To: Matt Janke – OEO, LLC
From: Audem Gonzales, Planner
Date: May 28, 2019
Re: PP-001058-2019: Parkdale Preliminary Plat No. 2
SP-001060-2019: Parkdale Site Plan No. 3
PUDA-001059-2019: Parkdale Planned Unit Development Amendment No. 2
cc: Fred Starr, Chad Schroeder, Joe Smith, Darren Champion

Town staff has reviewed the PP-001058-2019: Parkdale Preliminary Plat No. 2, SP-001060-2019: Parkdale Site Plan No. 3, PUDA-001059-2019: Parkdale Planned Unit Development Amendment No. 2 applications for conformance with Municipal Code, Title 10 at the May 9, 2019 Development Review Team meeting. A list of the Town staff that have commented and referral agencies that have responded are listed below. Referral comments received by the Town after the date of this memo shall be forwarded on to the applicant.

Project: **Parkdale Filing No. 3 – Preliminary Plat (PP-001058-2019); PUD Amendment (PUDA-001059-019); Site Plan (SP-001060-2019)**

Subject: Parkdale – Preliminary Plat 2, PUD Amdt 2 & Site Plan 2

Sheet L8

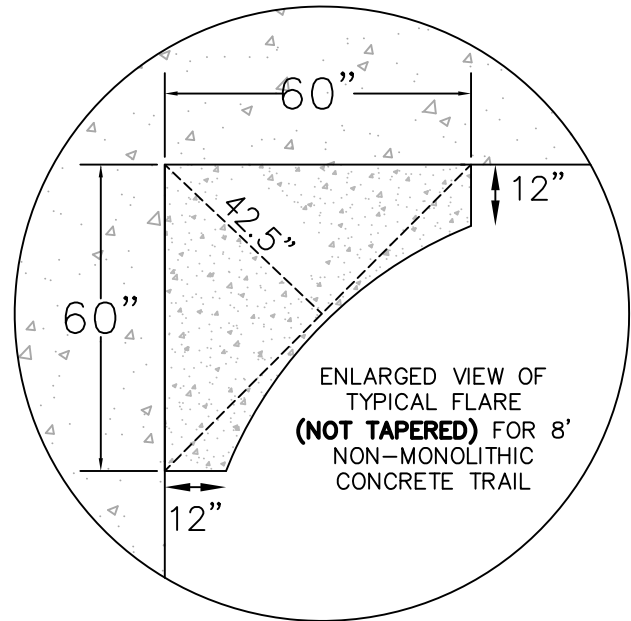
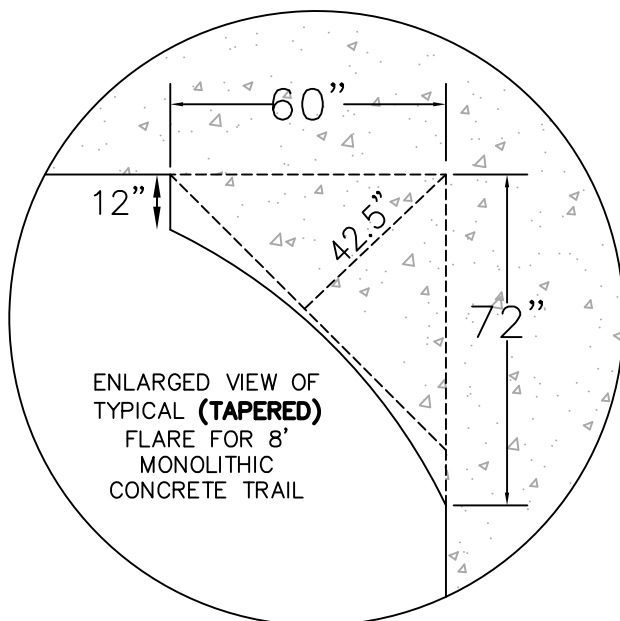
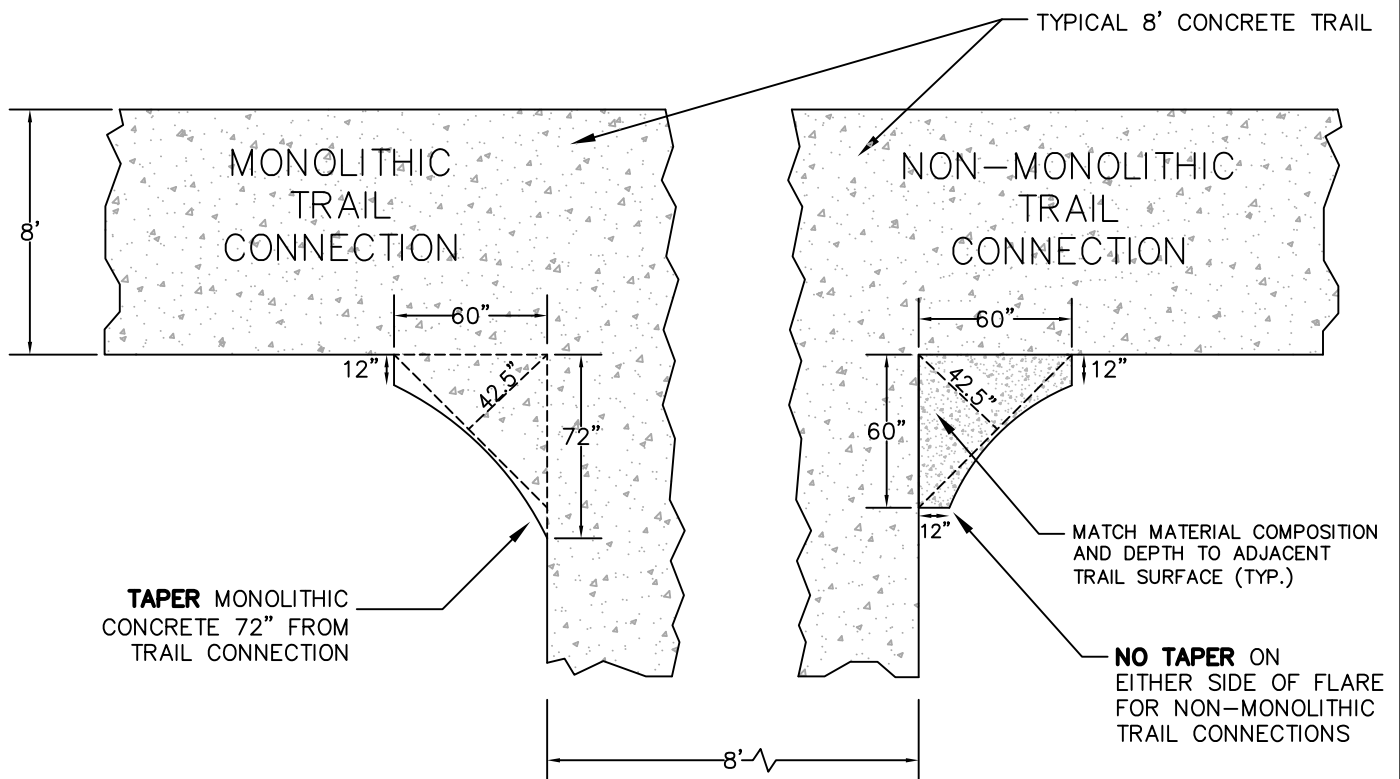
- Center the SW10A style curb ramp to the spine trail where it connects.
- Reduce the sod area located in Tract H and immediately adjacent to the spine trail. Replace with shortgrass native grass seed within the first 10-15 ft. of the crusher fines.
- Add trail stop signs to either side of Road F at the point where the spine trail crosses.

TYPICAL SECTION - CRUSHER FINES LOCATED ON UPHILL SIDE

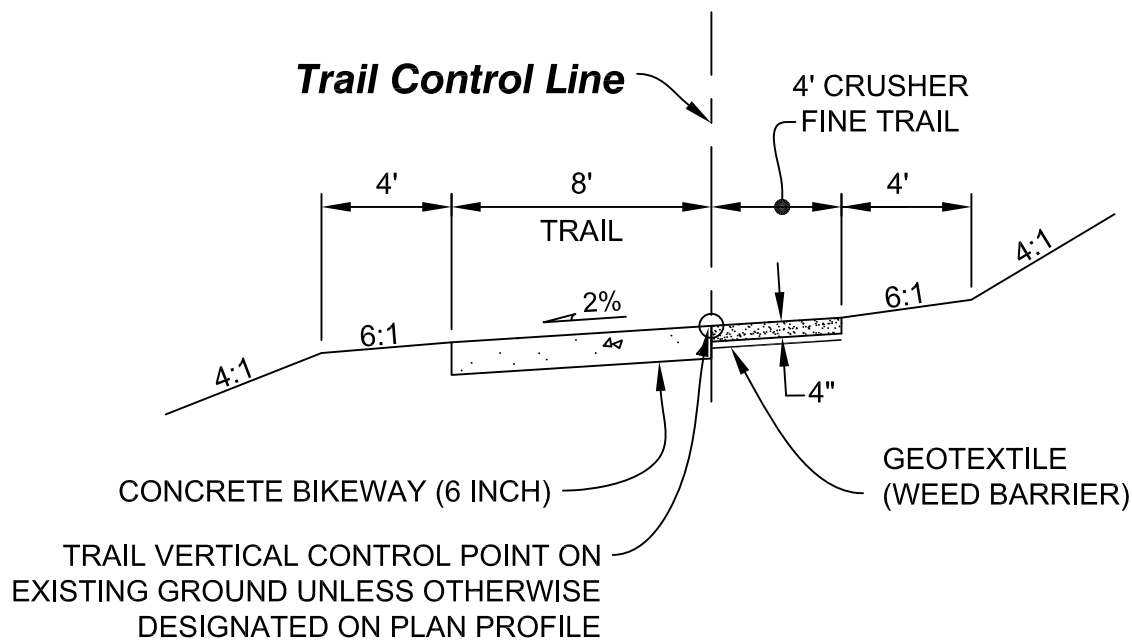
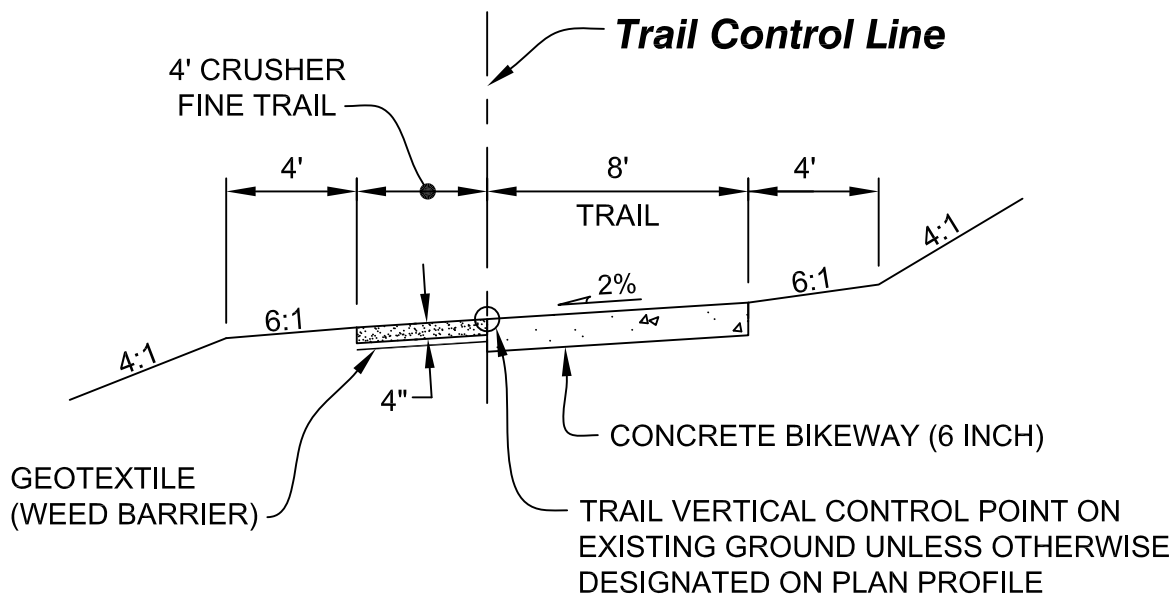
- Add the P25 spine trail design detail that is attached below. Please use the typical section that is shown at the top of Detail P25.
- There appears to be a conflict with the following requirement at the intersection of Road A and 119th Street: trees are not to be located within 55 ft. from the point of curb return at road intersections where a stop sign is present.
